**AMENDED**

PROJECT	THORPE GREEN HOUSE		
CLIENT	MR & MRS VERRILL THORPE GREEN HOUSE ROBIN HOOD'S BAY YO22 4TW		
TITLE	PROPOSED INTERNAL FLOOR PLANS & EXTERNAL ELEVATIONS		
STATUS	DATE	SCALE	REV
PLANNING	02.05.2012	1:100 / 1:50 @ A1	D
DRAWING NO.	TG PL-03		
THIS DRAWING IS FOR PLANNING PURPOSES ONLY AND NO OTHER USE.			
ALL DIMENSIONS SHOWN ARE PROVISIONAL AND ARE SUBJECT TO ON SITE CONFIRMATION AT THE START OF THE CONSTRUCTION STAGE - ANY DISCREPANCIES ARE TO BE REPORTED TO THE EMPLOYER IMMEDIATELY.			
UNITY CENTRE , 85 BOLE HILL ROAD SHEFFIELD , S6 5DD			
JD

TITLE **EXISTING & PROPOSED SITE PLANS AND  
PROPOSED GATE WIDENING DETAIL**

DRAWING NO. **TGH PL-02**

1:100 PROPOSED GROUND FLOOR PLAN

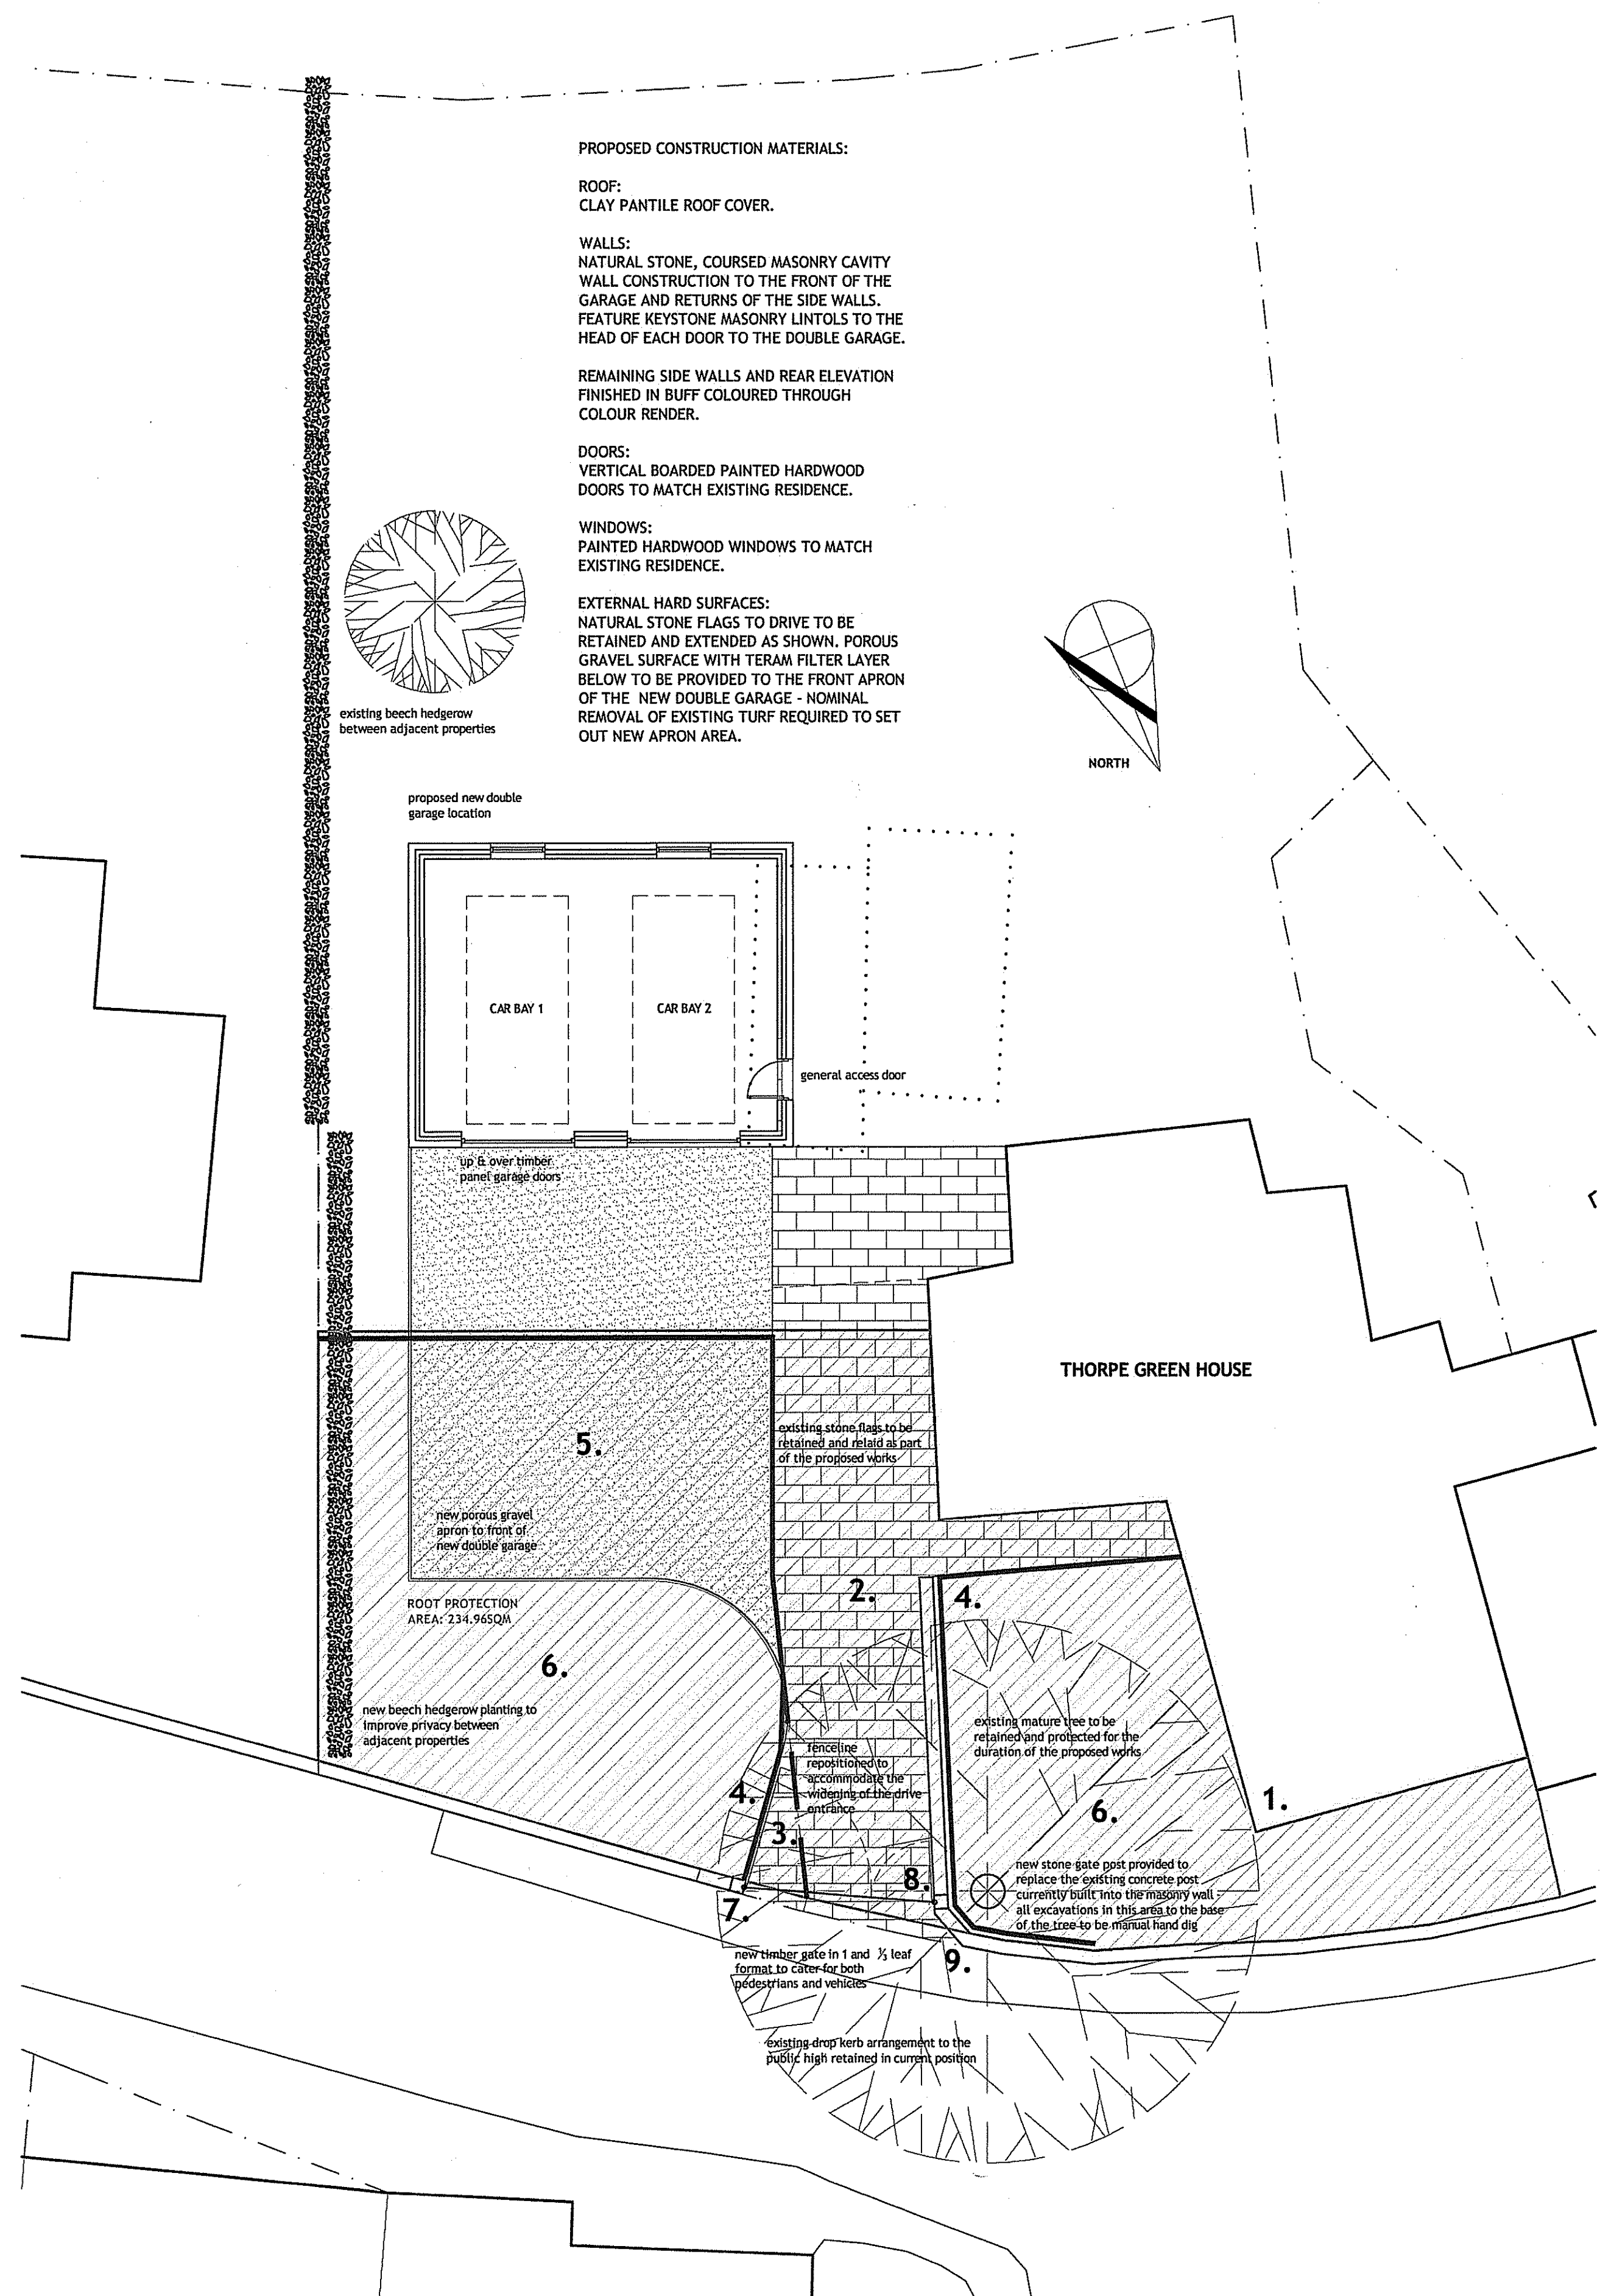
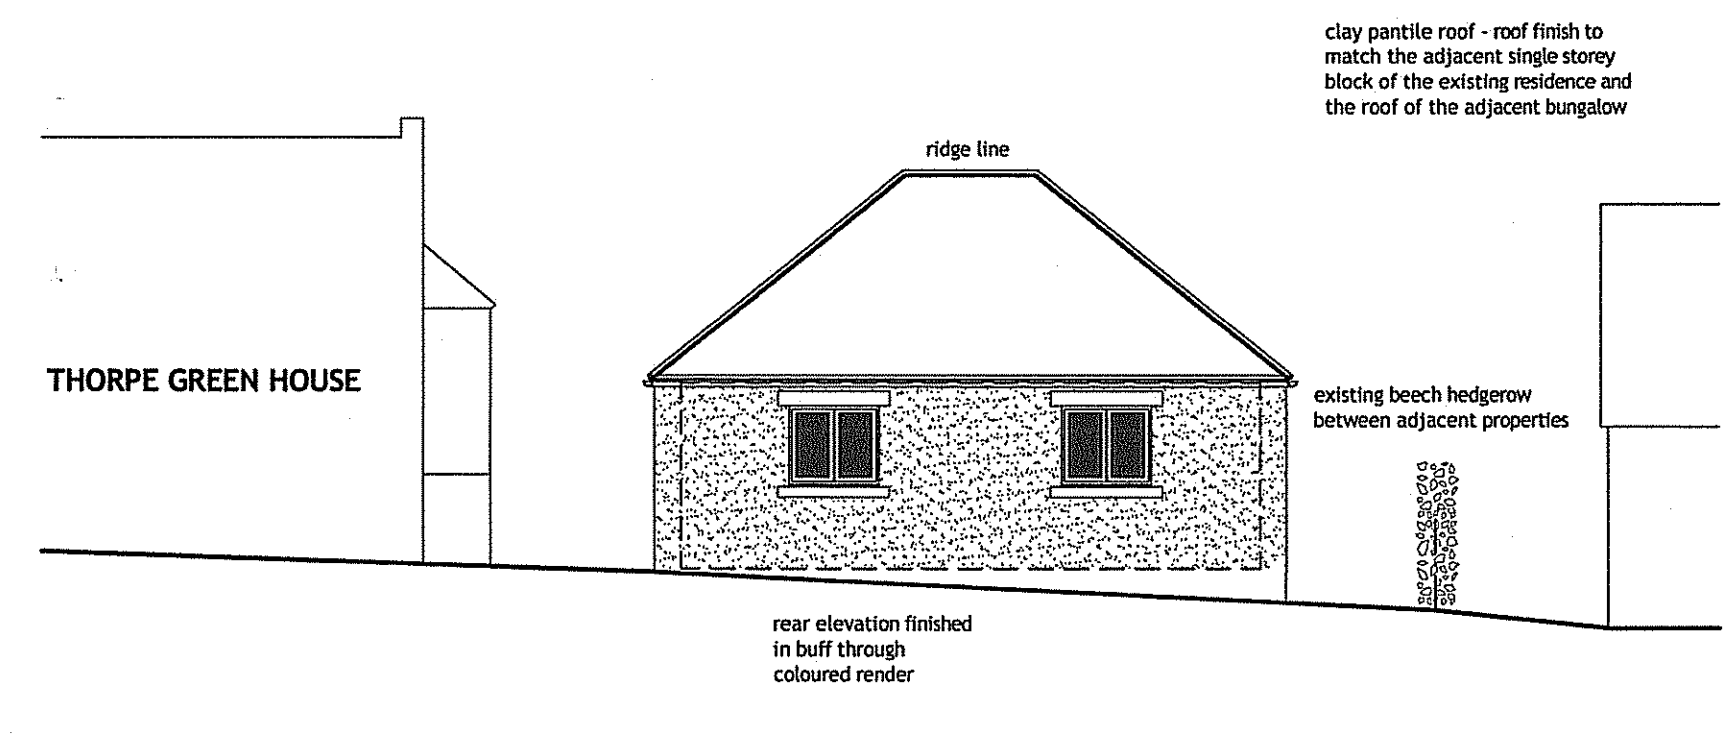
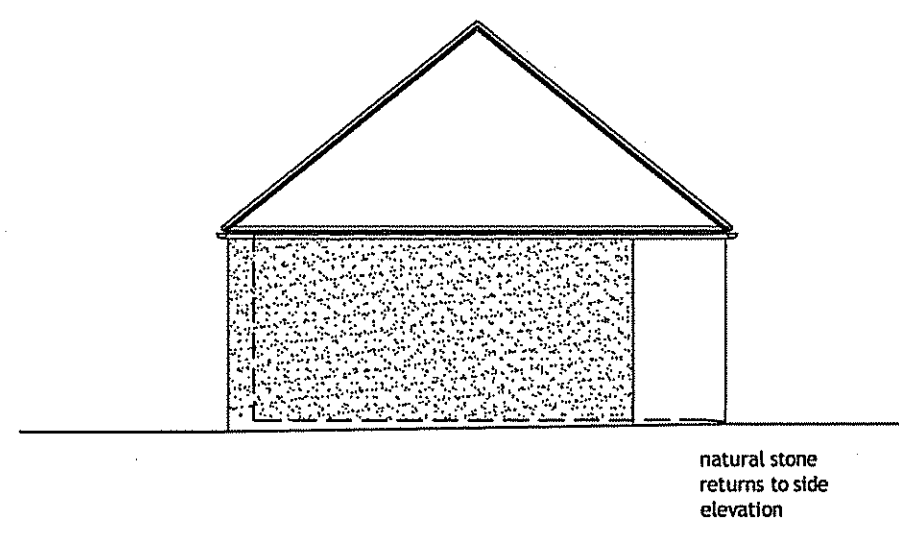
Notes  
Amended design - hipped roof.

REVISION D - 3 AUGUST 2012 - JD  
Hipped roof structure added to double garage to address concerns raised by conservation officer in NYMNP e-mail dated 2 August 2012.

1:50 PROPOSED SITE ENTRANCE

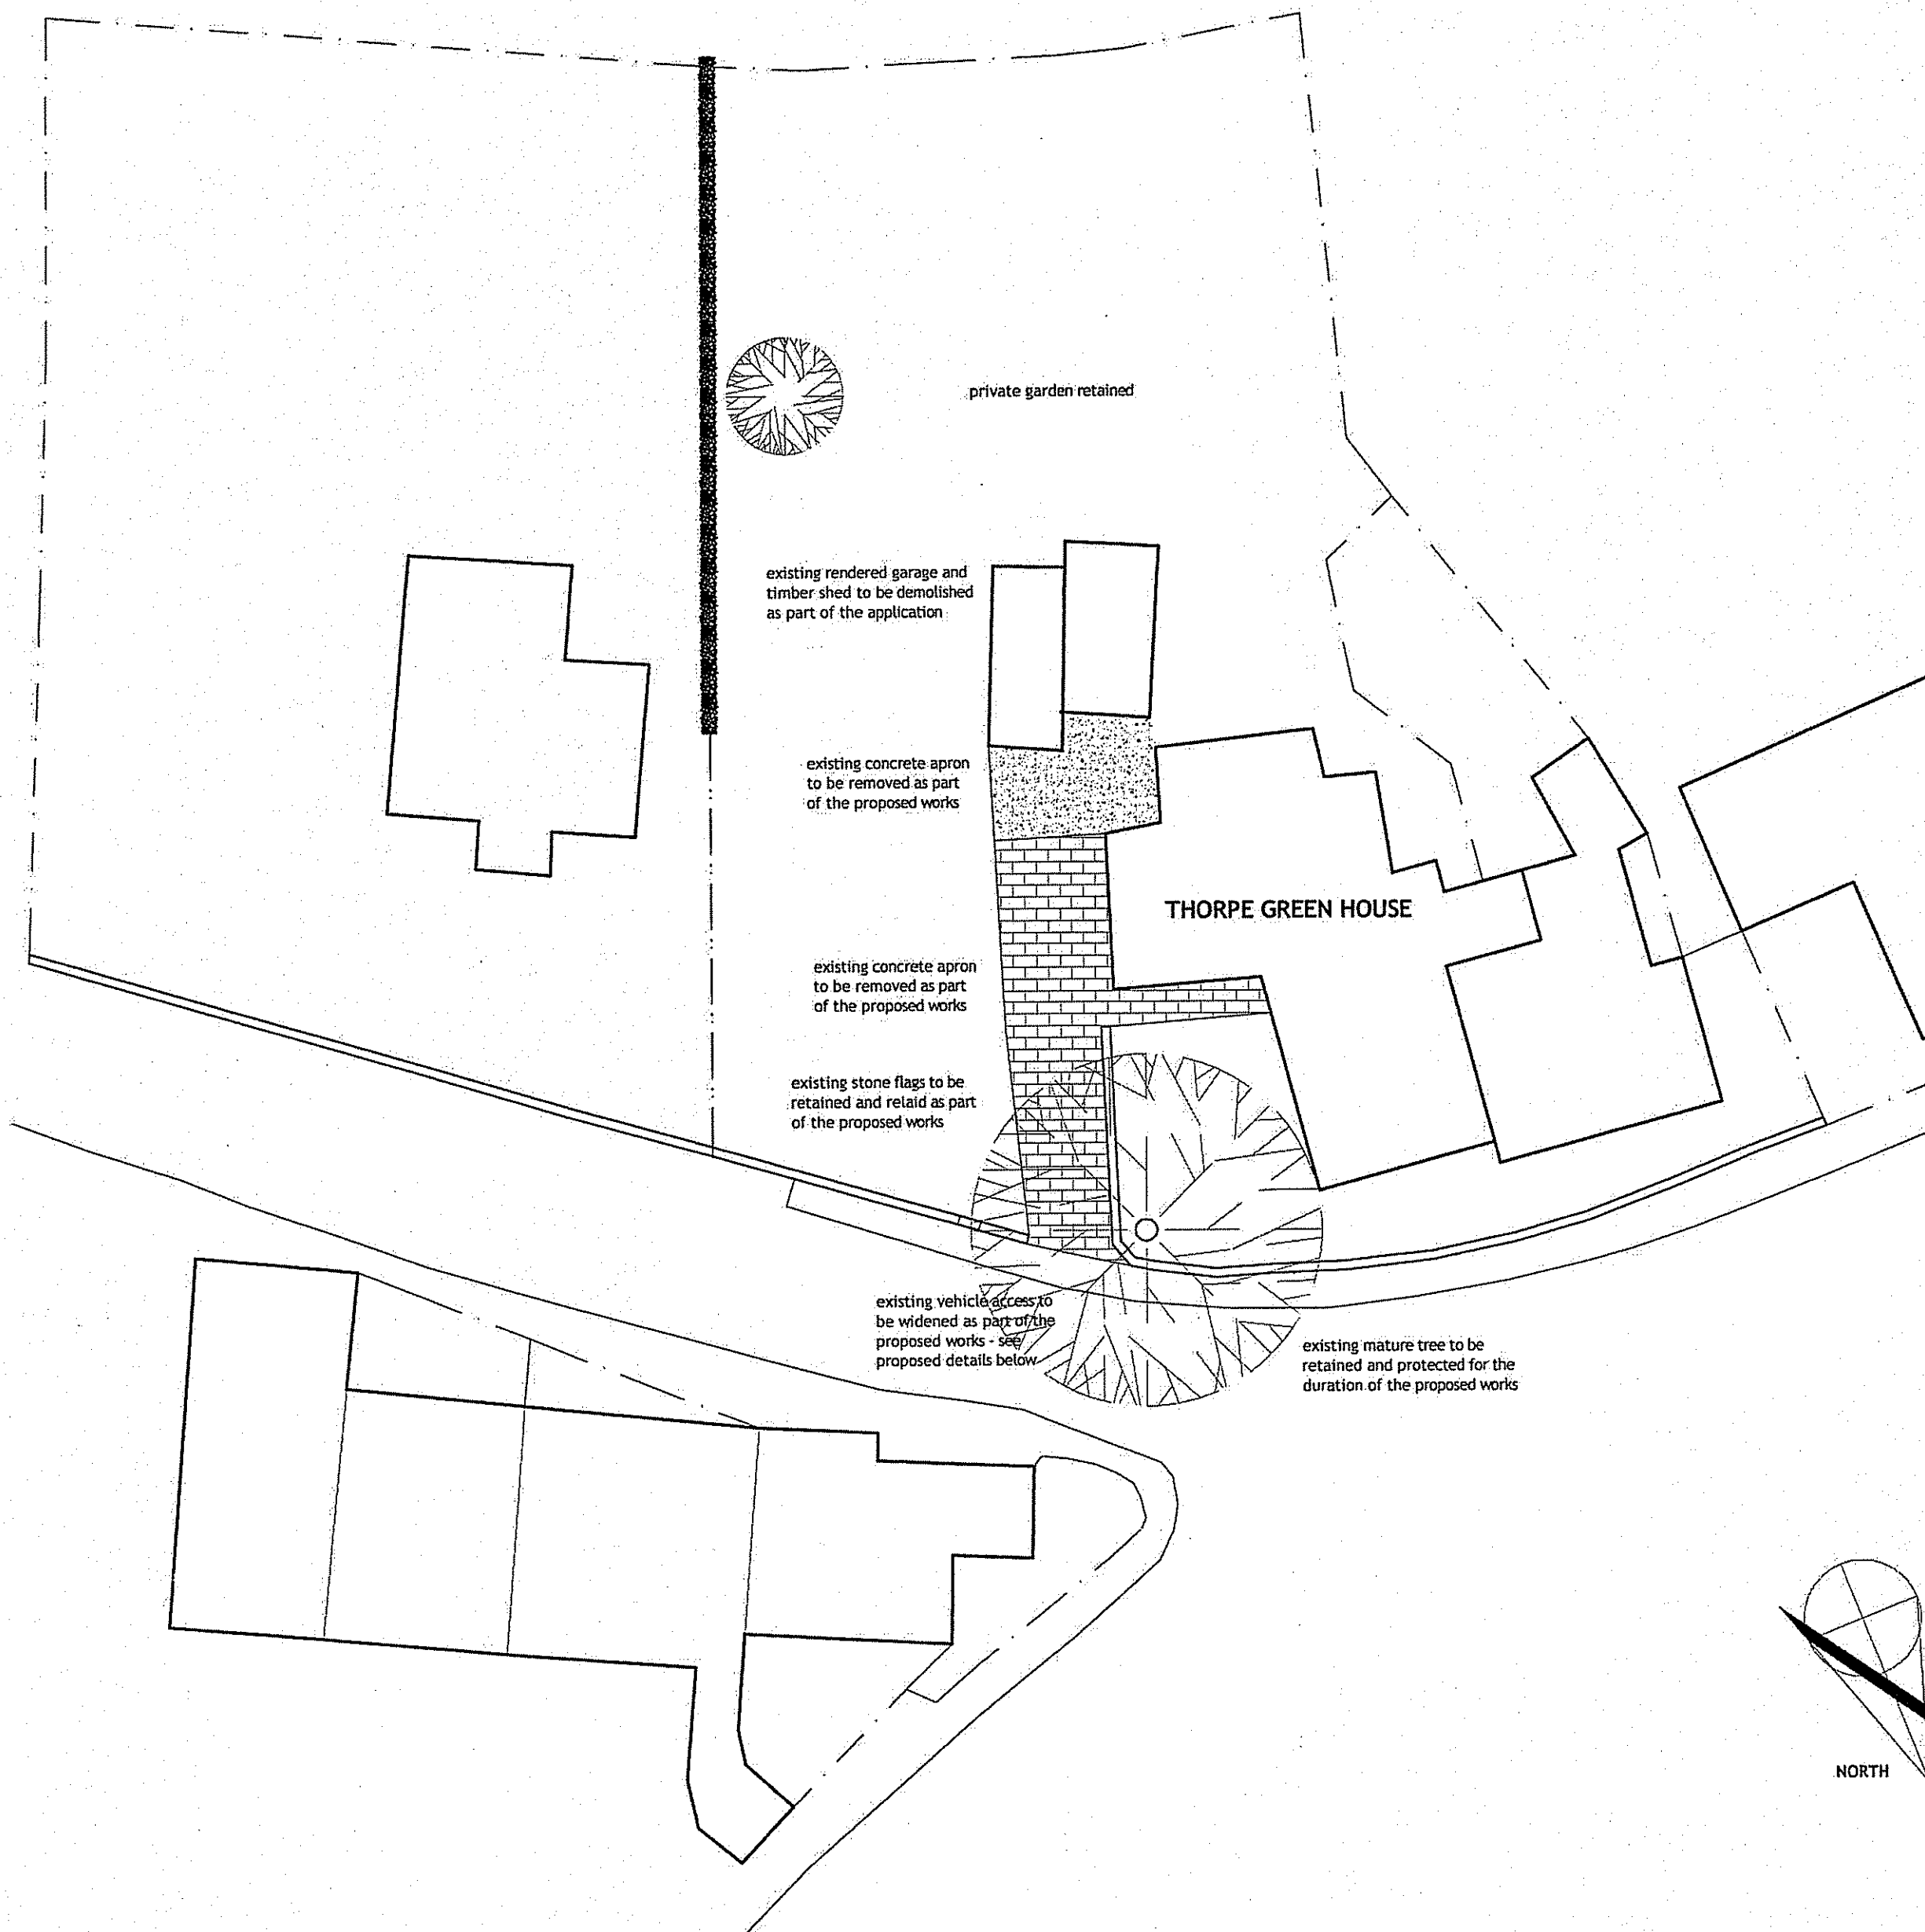
REVISION C - 25 JULY 2012 - JD  
Works within the Root Protection Area clarified inline with recommendations received from NYMNP in their e-mail dated 23 July 2012 - drawing updated to include calculated RPA, protective fence line and method statement for working in and around the designated RPA.

**WORKS WITHIN ROOT PROTECTION AREA - METHOD STATEMENT:**

- The existing tree is 720mm diameter with a root protection area (RPA) with a radius of 860mm or area of 234m<sup>2</sup>. Due to the rooting zone being restricted by the road and house, the area required by the tree (shown in green hatching) has been applied to the area of the site likely used by it.

- The RPA will be protected (fenced using hedges panels the line of which is shown in blue) during development of the site when construction of the garage and the gravel drive in front of the garage proceeds to avoid further compaction. Fencelines have been shown on the adjacent tree protection plan as part of this method statement and are to remain in position for the duration of the works.

- The proposed drive area to the front of the garage within the RPA is to be formed over a geotextile membrane and sharp sand bedding layers onto which a free draining reinforcement system, such as gravel pave or similar will be placed. This containment system requires no ground level excavation and will spread the vehicle loads from the cars into the existing ground structure. It will also retain the gravel surface and prevent wash out and rutting of the completed surface.

- The new gate post to the west of the site entrance will be set into a hand dug hole to minimise potential root damage within the RPA.
  - The post on the east side will be removed by hand along with its concrete encasement/foundation, the resulting hole will then be carefully enlarged by hand digging a foundation pit sufficient to receive the new masonry post. The excavated hole will be lined with 1200 gauge visqueen membrane to prevent contamination of the RPA by concrete poured in around the post base.
